COMMUNITY BOARD FEEDBACK PACKAGE

Business Name: Flex

Cafe Location: 405 WEST 51 STREET, NEW YORK, NY, 10019

Application Number: 20240802010251

Roadway Cafe Site Plan Form

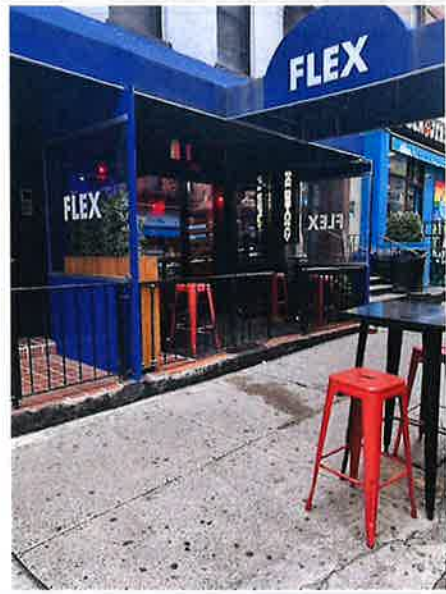
MCB4 recommends approval
